30-039-23266 CANYON LARGO UNIT #328

HILCORP ENERGY COMPANY
CANYON LARGO UNIT 328
P&A NOI

Re: Permanent Abandonment
Well: Canyon Largo Unit 328

CONDITIONS OF APPROVAL

CANYON LARGO UNIT 328 - PROPOSED WELLBORE SCHEMATIC

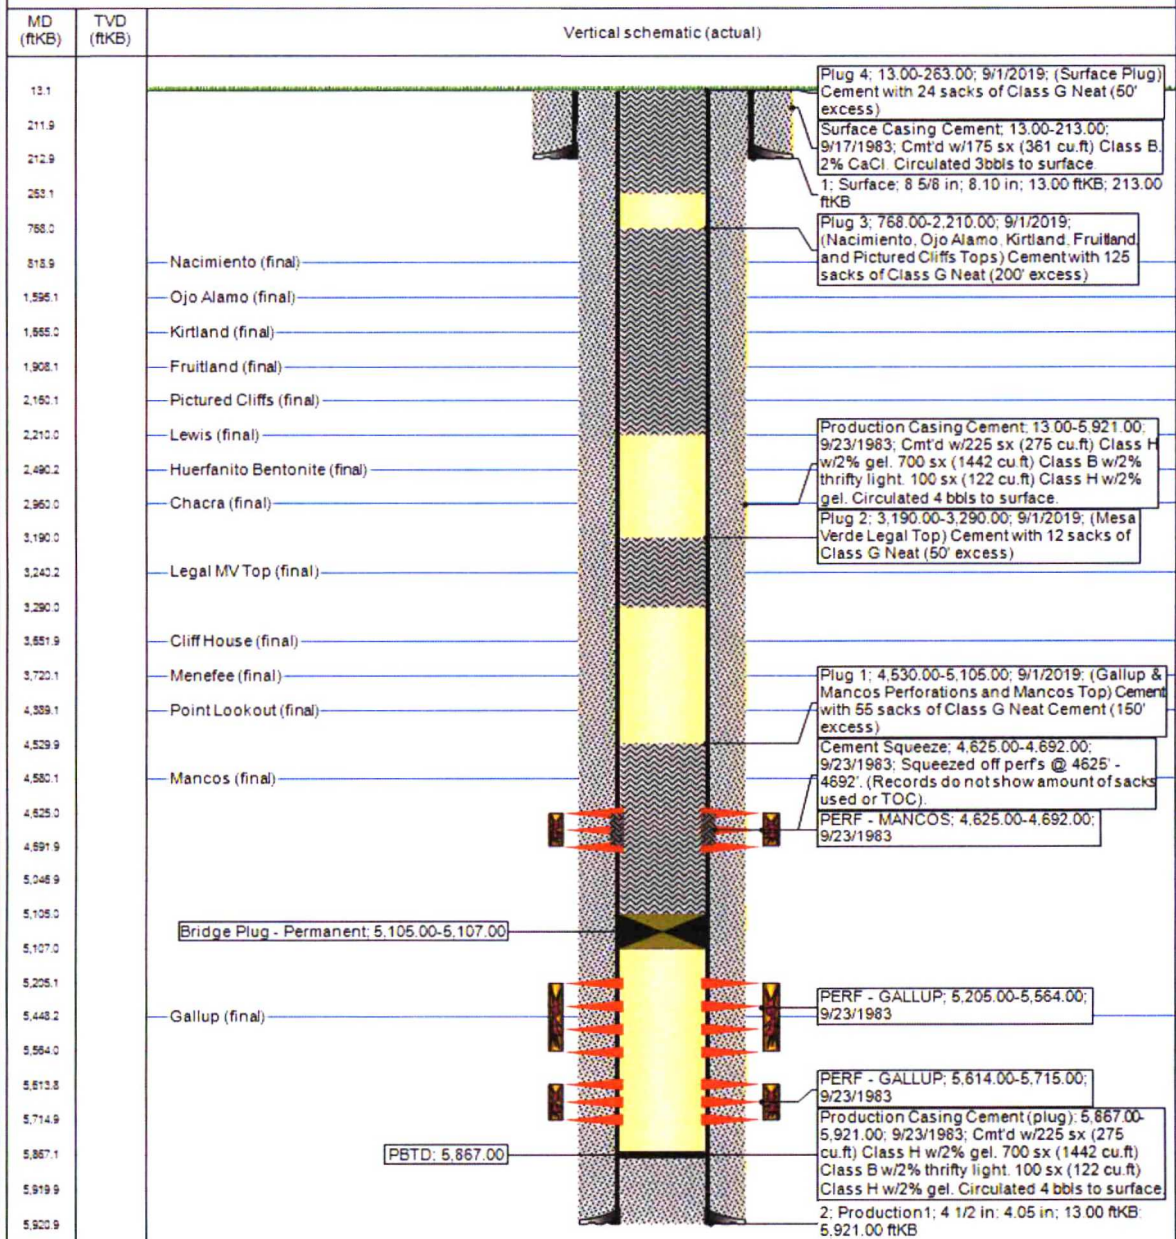
- Notify NMOCD 24hrs prior to beginning operations.
- Add Chacra Plug 3010'-2910'. OCD Chacra top: 2960'

1. Plugging operations authorized are subject to the attached "General Requirements for Permanent Abandonment of Wells on Federal and Indian Lease."
2. Farmington Office is to be notified at least 24 hours before the plugging operations commence (505) 564-7750.
3. Submit electronic copy of the CBL for verification to the following addresses: jkillins@blm.gov and Brandon.Powell@state.nm.us . Based on CBL results inside/outside plugs and volumes will be adjusted accordingly. Please review the Genereal Requirements document to ensure volumes meet required excess inside and outside casing.
4. Add an additional plug (3,602'-3,702') to cover Cliffhouse top at 3,652
